BEACON PLANNING BOARD One Municipal Plaza - Courtroom BEACON, NEW YORK 12508

The Planning Board will meet on **Tuesday, February 11, 2020** in the Municipal Center Courtroom. A work session will take place at 7:00 PM for a training workshop, discussion of agenda items and/or topics of interest to the Planning Board. The regular meeting will begin immediately thereafter, but not later than 7:30 p.m.

Re: Response to John Clarke Comments dated 01/10/2020, and Lanc & Tully Comments dated 01/08/2020, 248 Beacon Holdings LLC - Fishkill Creek Development Site Plan for 248 Tioronda Avenue (Formerly Beacon 248 Development, LLC, Multifamily Development) 248 Tioronda Avenue, City of Beacon, Dutchess County, NY Chazen Project #81750.00

designed checked
APB LAB
date scale
09/10/18 AS SHOWN
project no.
81750.00 sheet no. C162 8 of 17

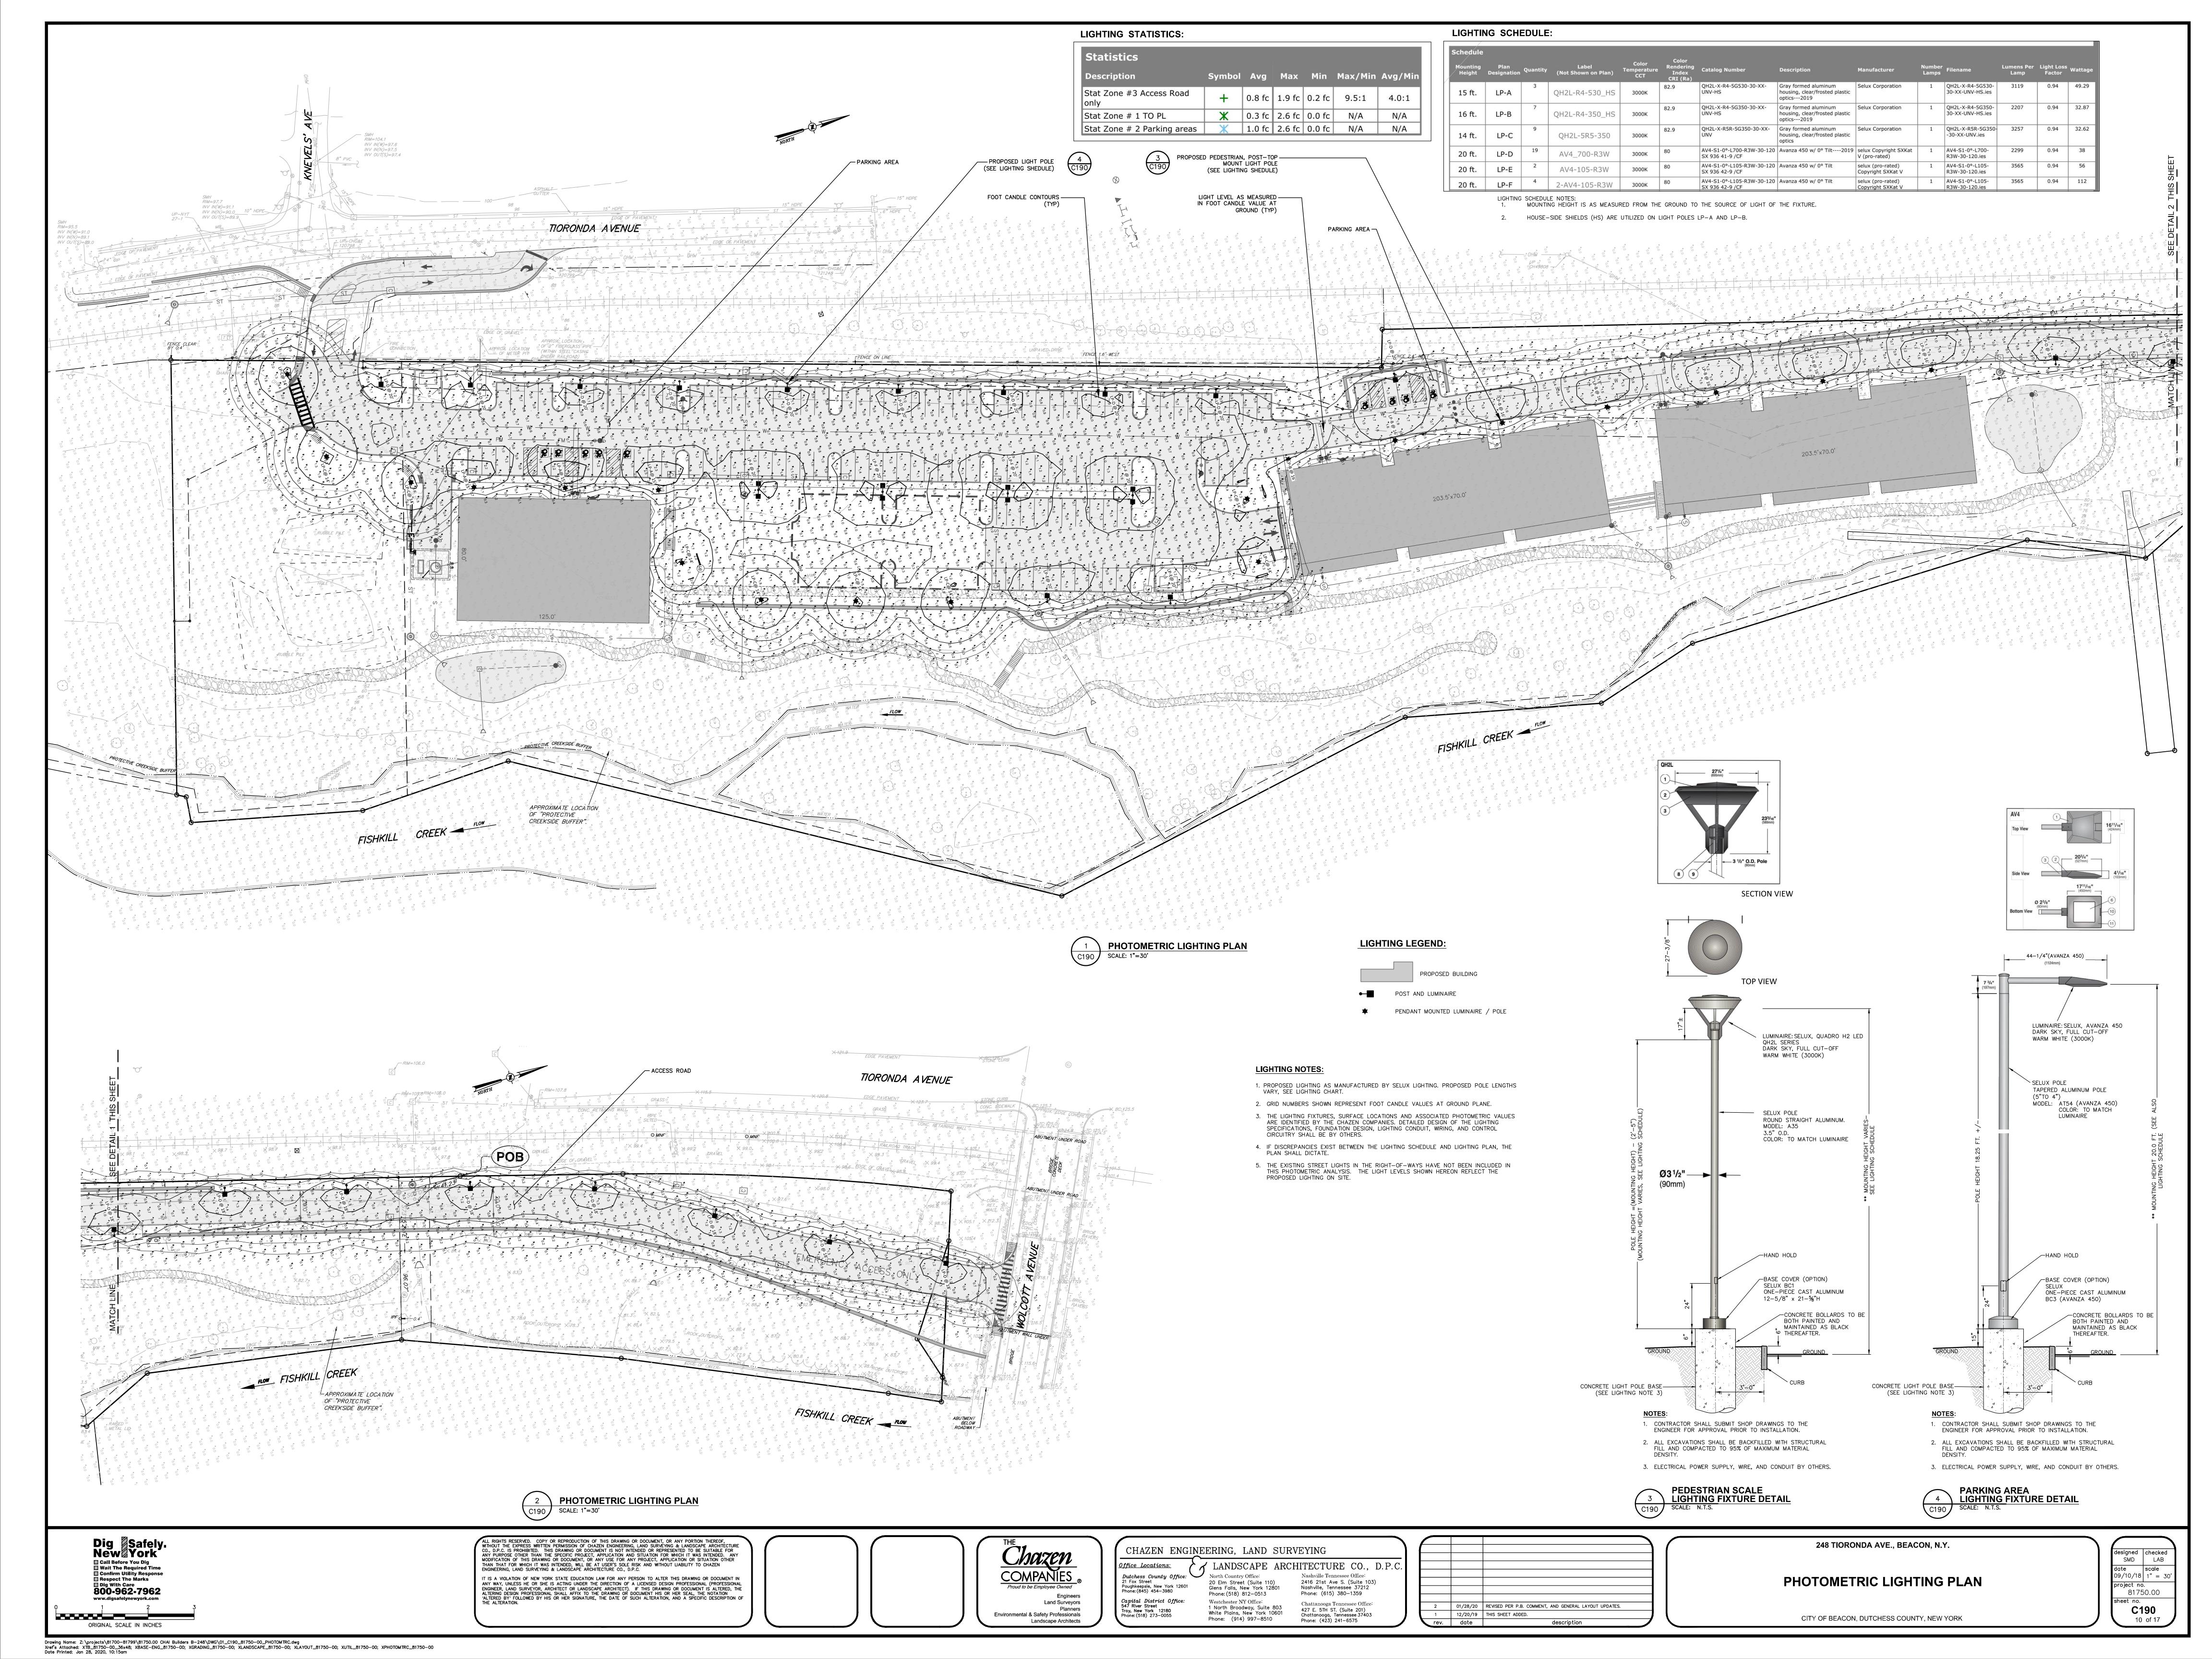
Sheet C162- Utility Profiles 2:

- 2. Several of the storm profiles have stationing labels that overlap, making it illegible. This shall be fixed accordingly.
- 3. Storm Profile 13 shows that there needs to be a vertical separation of 18" from the storm pipe to a pipe that is not labeled. The water pipe that the storm pipe is crossing should be labeled accordingly.
- 4. On Storm Profile 9, the frame elevation for CB-2 does not match the elevation that is stated on Sheet C160 Utility Plan and shall be fixed accordingly.
